POLICY REPORT DEVELOPMENT AND BUILDING

Report Date: September 4, 2012
Contact: Kent Munro
(authored by
Karen Hoesse)
Contact No.: 604.873.7135
RTS No.: 9646
VanRIMS No.: 08-2000-20
Meeting Date: September 18, 2012

SUBJECT: CD-1 Rezoning - 475 Howe Street and 819 West Pender Street and Heritage Designation and Heritage Revitalization Agreement at 475 Howe Street

Figure 4 – Staff recommended measures to increase tower separation distance

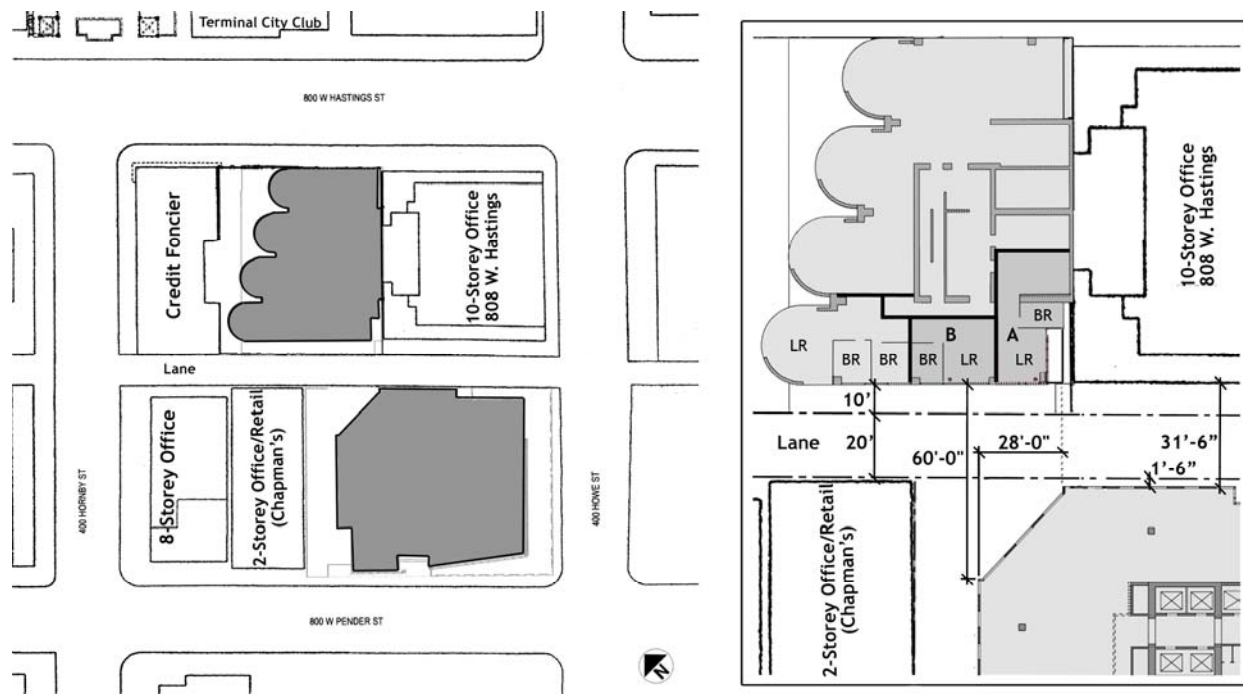
Staff believe that additional measures can be taken to address the proximity, private view, and access to daylight concerns raised by the residents of Jameson House. Although a further shifting of the proposed tower location to move it away from the Jameson House is not possible, staff worked with the applicant to explore options to sculpt the tower shape or to reduce the floor plate size. The applicant was concerned and continues to have concerns, about modifications to the tower floor plate give the need for the office space to be appropriately configured to compete with other commercial buildings in the CBD and given the challenging economics and viability of downtown office development. Nevertheless, where the proposed building and the Jameson House building are immediately adjacent, staff are recommending adjustments to increase the tower separation from 9.1 m (30 ft.) to as much as 18.2 m (60 ft.), as illustrated in Figure 4. In addition, staff recommend additional measures to mitigate direct sight-lines (i.e., such as permanent external louvers) and spillover lighting impacts between the two buildings.

Staff believe that these changes to the proposal represent a reasonable response that maintains the livability, light access and primary private views of the impacted units in the Jameson House. Staff also note that the resulting floor-plate of the proposed tower of approximately 1 101 m² (11,850 sq. ft.) is not an unusually sized office floor-plate within the CBD.

Recommended design development to the form of development to address proximity and view impacts to the Jameson House

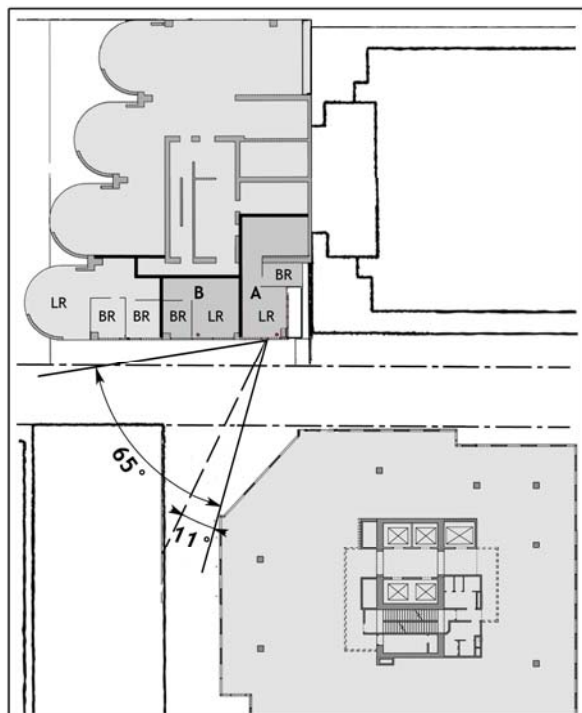
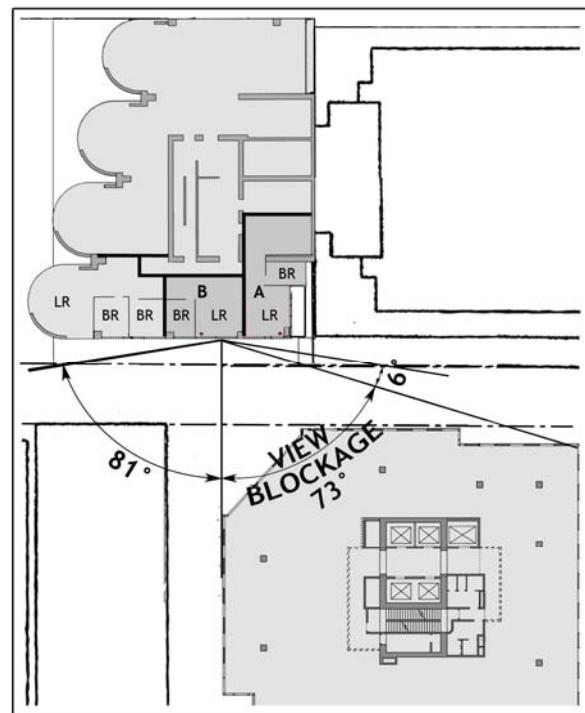
To address the concerns raised with the proximity between the two buildings, access to daylight and view impacts for the residents of Jameson House, staff are recommending a number of design development conditions. As illustrated below, staff are recommending design development to the northwesterly corner of the office building to increase the separation between the two buildings through a modest reallocation of floor space from the northwest corner of the proposed office tower. This would provide for provide a modest increase of 11 degrees in the view aspect for the lane-facing windows of Unit A, noting however that would not generate any perceivable increase in the view aspect for Unit B with this increased separation.

Unit A - Levels 14 to 37 (24 units)
Increased by 11 degrees

Unit B - Levels 14 to 31 (18 units)
Unchanged
